# SERVICE BULLETIN

DATE: 19 OCTOBER 2005  
PAGE 1 OF 6

## FUEL PROBE LABEL REPLACEMENT

### Service Bulletin SB900-098, Fuel Probe Label Replacement

**Figure 1. Fuel Probe Label Replacement**

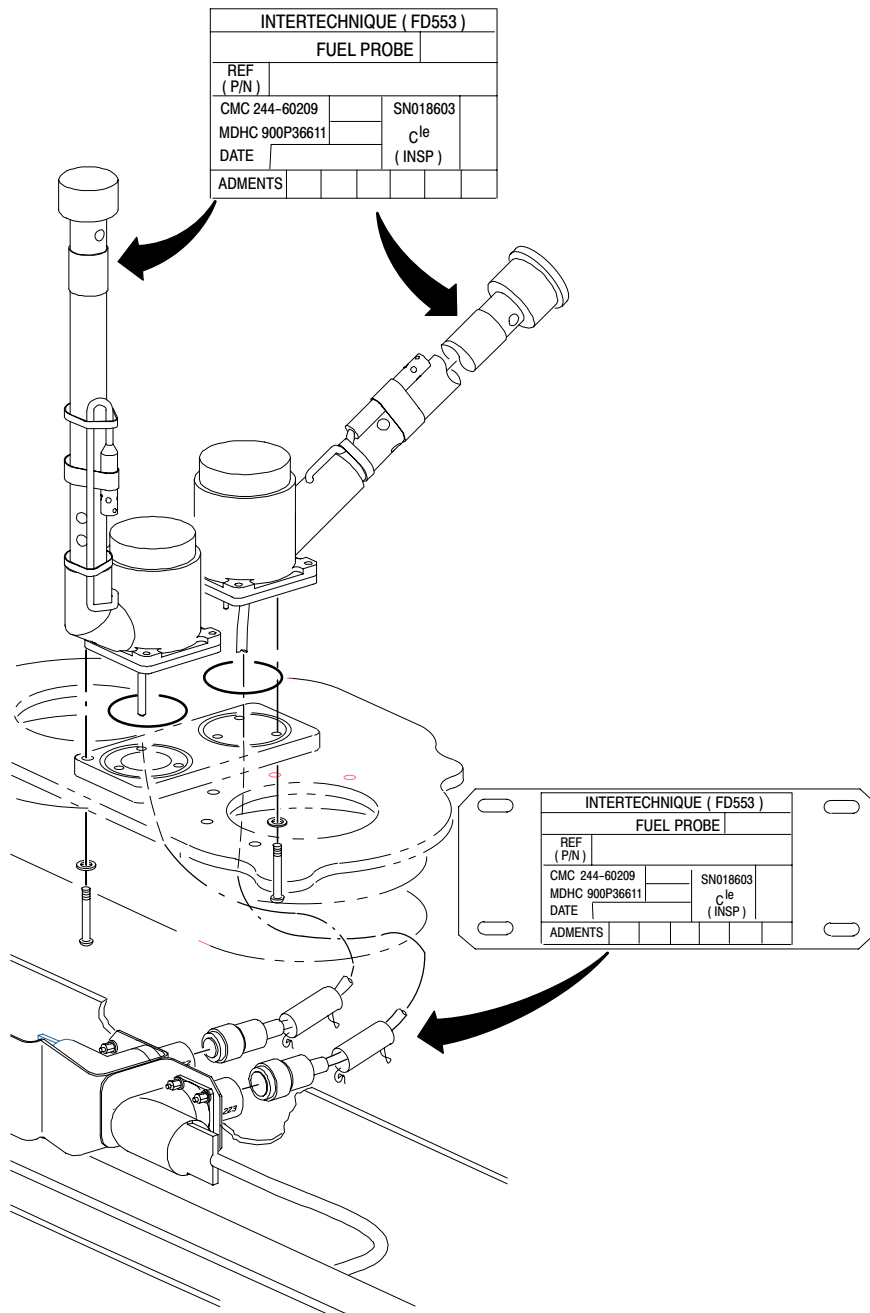
The adhesive holding the fuel probe labels to the probes could deteriorate from immersion in fuel and the label could detach from the probe. The detached label could migrate to the engine fuel pump inlet, partially blocking or restricting fuel flow to one of the engines.

Procedures in this Bulletin provide owners and operators with information pertaining to removing the metal labels from the forward and aft fuel probes and attaching a new label to the associated probe wire harness outside the fuel cell.

- (1). Remove Sump Access Panel (B178) (Ref. CSP-900RMM-2, Section 06-00-00).
- (2). If both Fwd and Aft Fuel Probes have identification labels on the electrical pigtails external to the fuel tank, as shown in Figure 1, the intent of this Bulletin has been met. Proceed to step 4. Compliance Record.

- (1). Transfer label information on forward probe to new label supplied, using permanent ink pen.
- (2). Attach new replacement label onto forward fuel probe wire harness using lacing tape (C703).
- (3). Transfer label information on aft probe to new label supplied, using permanent ink pen.
- (4). Attach new replacement label onto aft fuel probe wire harness using lacing tape (C703).

- (1). Peel label from forward and aft fuel probe. If necessary, use an X-Acto knife or other sharp blade to cut through label edge seal to expose edge of label.
